REFERENCE NO: RF-16-04

**SUBJECT: 2016 MAZDA3 (MEXICO BUILT) – CHANGE IN A-PILLAR CLIP (SERVICE PART D09W-68-162) FOR ACCESSORY INSTALLATION**

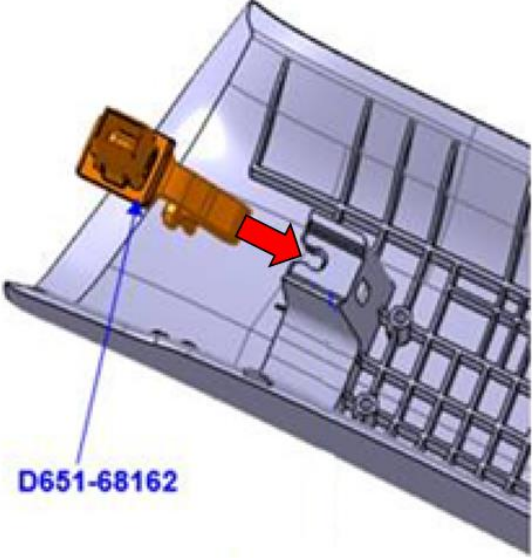
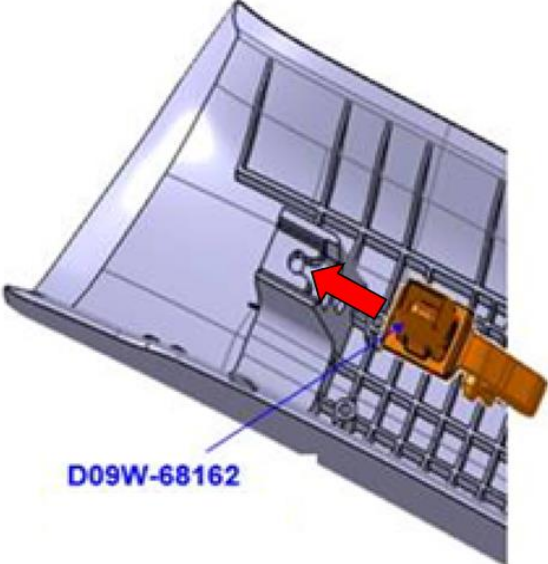
There was a change in the A-pillar on the 2016 Mazda3 (Mexico built only), and some accessories are impacted by this. When installing one of the applicable accessory parts to the applicable vehicles, discard the existing A-Pillar Clip (Color: Black) inside the kit(s), and use a service part A-Pillar Clip (Color: White, PN: D09W-68-162) in its place. The Black clip cannot be installed properly on the A-pillar trim.

NOTE: The white A-pillar clip is not included in the accessory kit(s) and must be obtained separately.

DISCARD

USE

PN# D09W-68-162  
( Color: WHITE )

**REMOVED.** After removing the A-pillar trim, see what color the A-pillar clip is. If the A-pillar clip is white, then replace it with a new white clip. If the A-pillar clip is black, replace it with the black clip in the accessory kit.
